**Director's Report**  
**for Indiana Michigan Power Company's 2018-2019**  
**Integrated Resource Plan**  
**February 12, 2020**

**Dr. Bradley Borum**  
Director of Research, Policy and Planning  
on behalf of the Indiana Utility Regulatory Commission

# Director's Report Applicable to Indiana Michigan Power Company's 2018-2019 Integrated Resource Plan and Planning Process

**Figure 10. Load Forecast Scenarios**

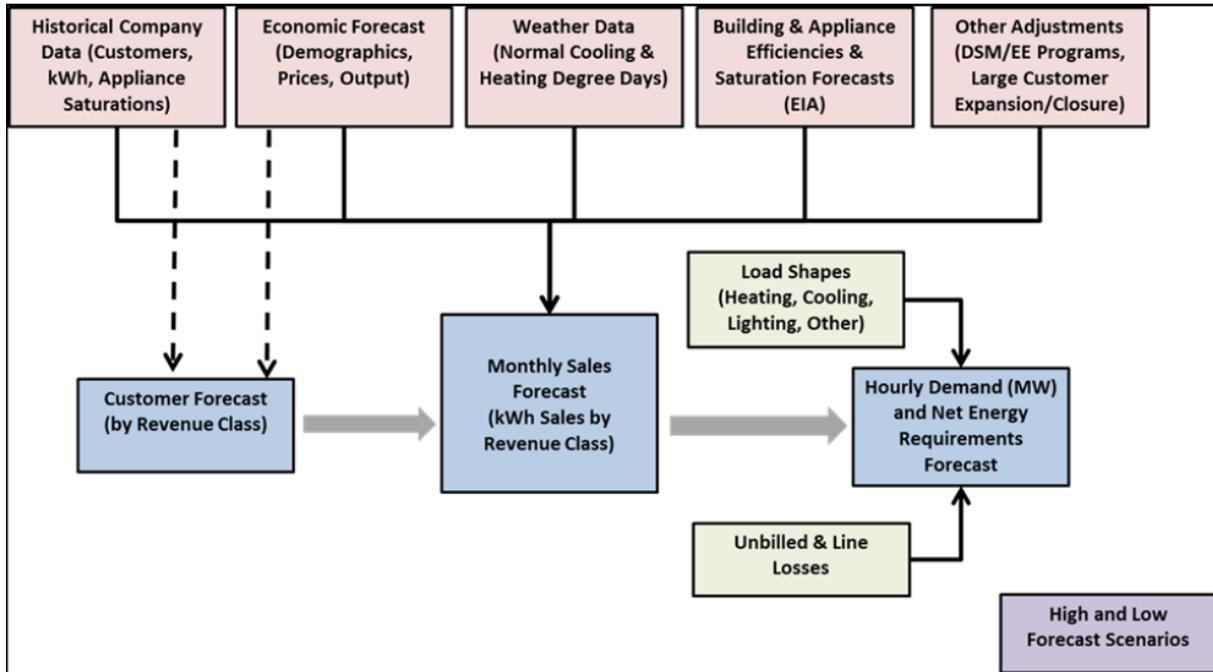
I&M said there have been only “a limited number of changes in the methodology” since I&M's 2015 IRP (*I&M IRP, page 27*), but only explicitly mentioned the change involving how the high-low economic growth model is now estimated separately for I&M and each operating company. It would have been helpful for I&M to enumerate any methodological changes. As I&M discussed the changing usage patterns, this is an appropriate predicate for I&M to undertake an evolutionarily significant continuing improvement process to better capture changing usage patterns and demographic changes for all classes of customers. Potential enhancements to I&M's methodology will be discussed in this Report.

Questions about how EE affected the load forecast remain. The need to implement a process to avoid the potential double counting of energy efficiency is reasonable. The use of degradation factors to lessen the potential for double counting, even if the factors are estimates, seems appropriate at a conceptual level. However, there are a number of EE-related concerns that will be addressed in the DSM discussion. The Director has some specific comments/questions such as:

**Company Response:** No. The Company has a single load forecast that is informed by both the short term and long term model results that is used in Integrated Resource Plan filings, Base Rate cases, fuel filings, and other rider filings. The Company leverages the strengths of two independent sets of forecast models that are useful in reviewing and validating the ultimate load forecast for I&M. The short-

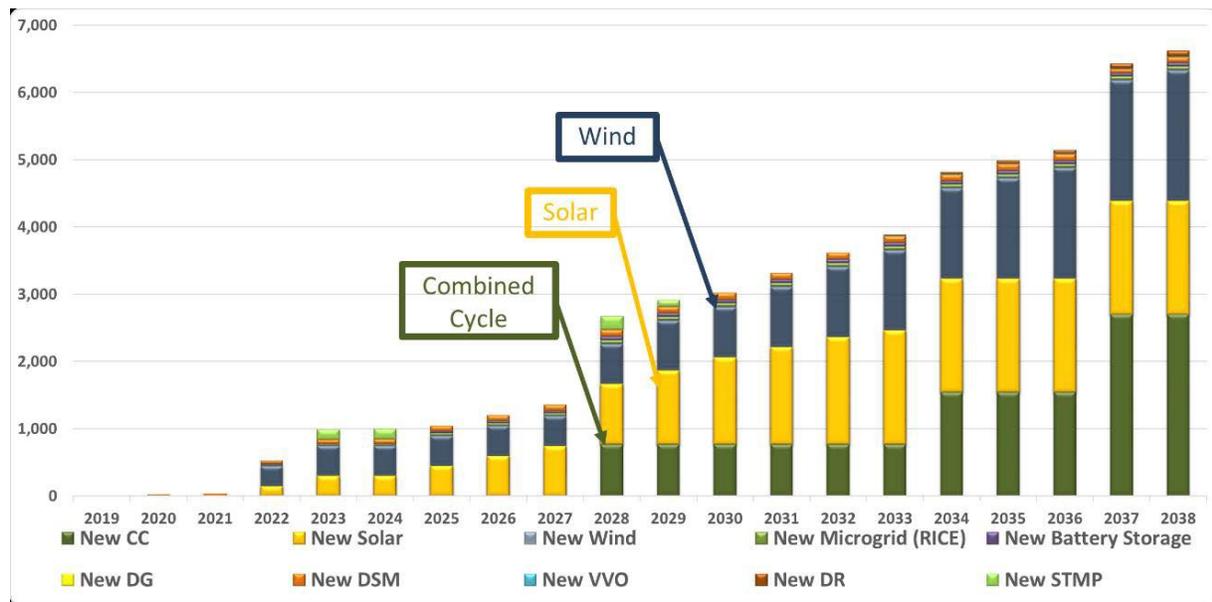
I&M states on Figure ES-1 below, “I&M’s assumed ‘going-in’ capacity position (i.e. before resource additions) over the planning period, ...Through 2022, I&M’s existing capacity resources meet its forecasted internal demand. In 2023, I&M anticipates experiencing a capacity shortfall, 484MW, based upon its assumption of the expiration of the lease of Rockport Unit 2. This capacity shortfall is anticipated to increase to 1,762 MW in 2028 upon the retirement of Rockport Unit 1. The retirement of Cook Unit 1 in 2034 and Cook Unit 2 in 2038 further increases I&M’s capacity shortfall to 4,060MW.” (I&M’s IRP, page ES-4)

- 4) The IRP document lacks a detailed description of how the Preferred Plan was chosen from the scenario analysis.

**Company Response:** Pages 130-131 of the IRP describe the specific considerations / criteria in developing the Preferred Plan. The Company will continue to work with all Stakeholders to improve the transparency and effectiveness of its communications because it is important for everyone to understand the reasoning and judgment employed by management to create the Preferred Portfolio. *(I&M Comments on Draft Director's Report, pg. 11 & 12)*
